Access Compliance Report

Public Rights-of-Way

(Curb Ramps)

Intersection ID: 12958	Main Street: E_3RD_ST	Cross Street: S_DAVIDSON_ST	Location: W
ADA ID: 386101FB760F	Ramp Type: PerpDiag	Initial Pass/Fail: Fail	Overall Compliance: No
		Severity Score: 10

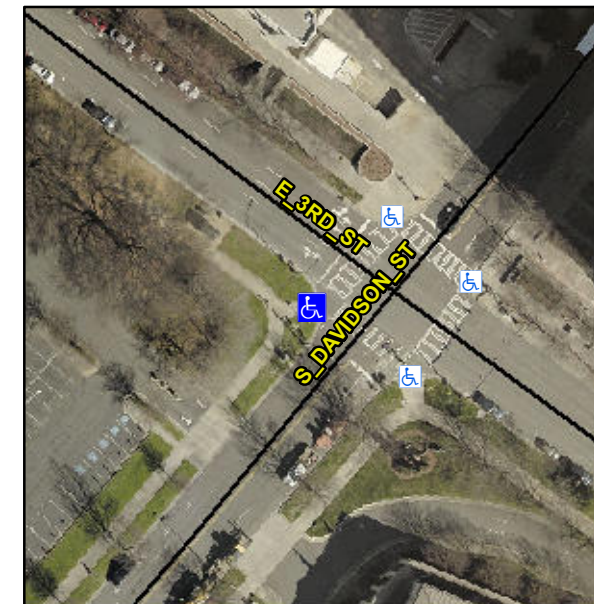
Not Found, R304.5.1, R304.5.3

Compliance	Description	Data	Compliance	Description	Data
N/A	Ramp Length (in)	118.0	Yes	Ramp Slope (%)	6.0
No	Ramp Width (in)	36.0	No	Ramp XSlope (%)	2.3
N/A	Flare Type LT	N/A	N/A	Flare Type RT	N/A
N/A	Flare Slope LT (%)	N/A	N/A	Flare Slope RT (%)	N/A
N/A	Flare Traversable LT?	N/A	N/A	Flare Traversable RT?	N/A
N/A	Landing Length (in)	N/A	N/A	DWS Provided?	N/A
N/A	Landing Width (in)	N/A	N/A	DWS Contrast?	N/A
N/A	Landing Slope (%)	N/A	N/A	DWS Length (in)	N/A
N/A	Landing X Slope (%)	N/A	N/A	DWS Full Width?	N/A
N/A	Landing Curb? (Y/N)	N/A	N/A	DWS Offset (in)	N/A
N/A	Shared Landing?	N/A			
N/A	Gutter Ponding?	N/A	N/A	Gutter Slope (%)	N/A
N/A	Gutter Lip Ht (in)	N/A	N/A	Gutter X Slope (%)	N/A
N/A	Painted X Walk1?	Yes	N/A	Painted X Walk2?	Yes
	X Walk 1 Direction	To SE		X Walk 2 Direction	To NE
N/A	X Walk 1 Width (in)	118.0	N/A	X Walk 2 Width (in)	120.0
	X Walk 1 Slope (%)	0.7		X Walk 2 Slope (%)	1.8
	X Walk 1 X Slope (%)	1.3		X Walk 2 X Slope (%)	0.2

Remove & Replace Curb Ramp With Two New Directional Ramps or Equivalent.
